This software updates or alters the functions and features noted below. The instructions and information that follow are meant as a supplement to the original instruction manual that accompanied the transmitter. Please refer to the original instruction manual where applicable, but replace the steps indicated below with these instructions. Please check to ensure that the update has been installed.

## 1. Compatibility of model data created with T18SZ 70th anniversary model

## ◆ Speed sensor screen

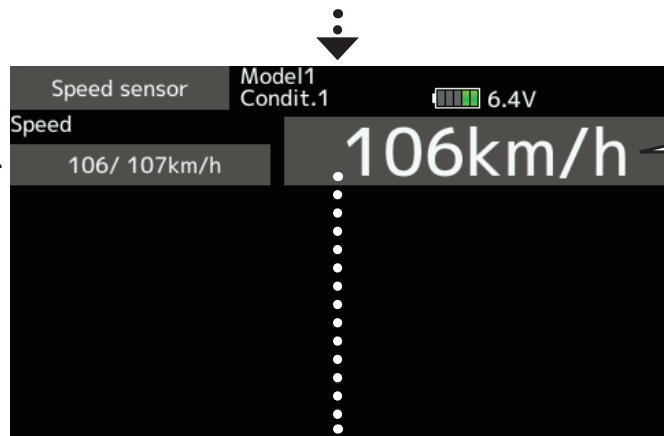
Max. and min. values since the power was turned ON will display.

## ◆ Alarm setting

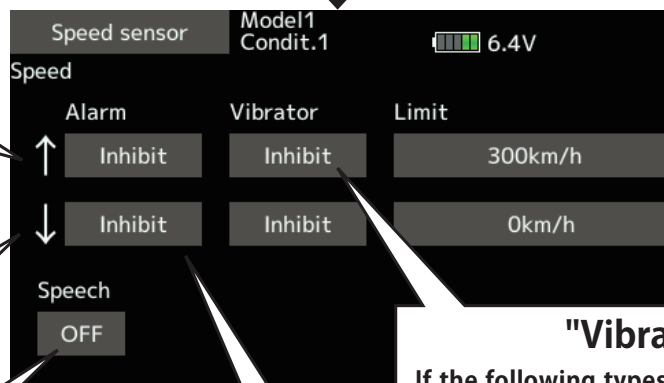
↑ An upward arrow indicates the alarm will sound when the speed reaches above your set value.

↓ A downward arrow indicates the alarm will sound when the speed reaches below your set value.

The ON/OFF switch of Speech is chosen.

A setup of the speed on which the alarm operates.

Alarm is chosen from Buzzer, Voice, and Inhibit.

### 4. Data Converter

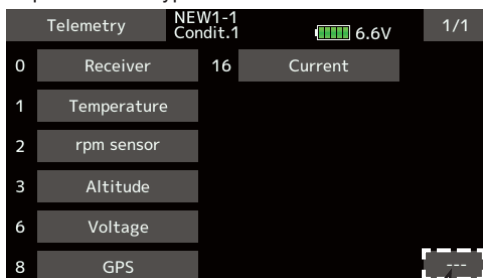
FX-30 and T12FG have been added to the data converter compatible models.

The transmitter name is displayed on icon.

### 5. Butterfly Elevator setting (Glider)

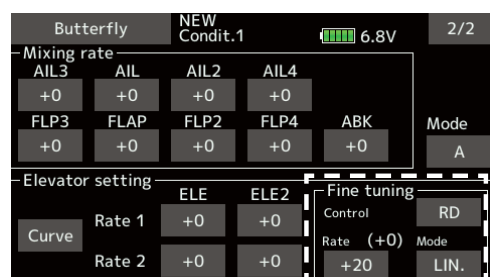
Added fine tuning function to butterfly elevator setting.

\*When Flying wing type, it was made not to display Elevator setting.

## 6. Butterfly mixing mode (Glider)

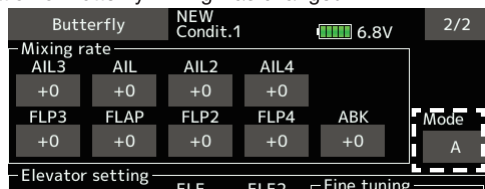
The operation of Butterfly mixing was changed.

Mode A, mode B selection added.

### • Mode A

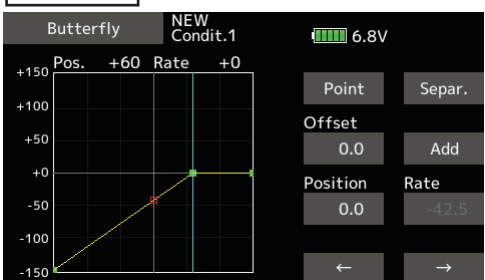
- The butterfly operation direction is reversed at the neutral position (50%) of the throttle stick.

The direction of butterfly motion is reversed.

### • Mode B

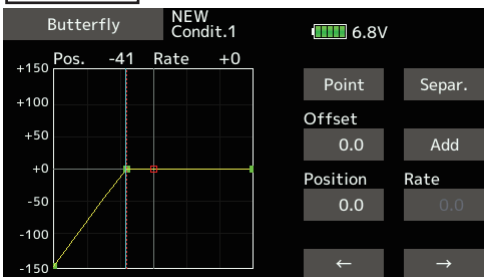
- It does not reverse at the neutral position, so you can set the butterfly operation start point with the full stroke of the throttle stick.

The direction of butterfly motion is not reversed.
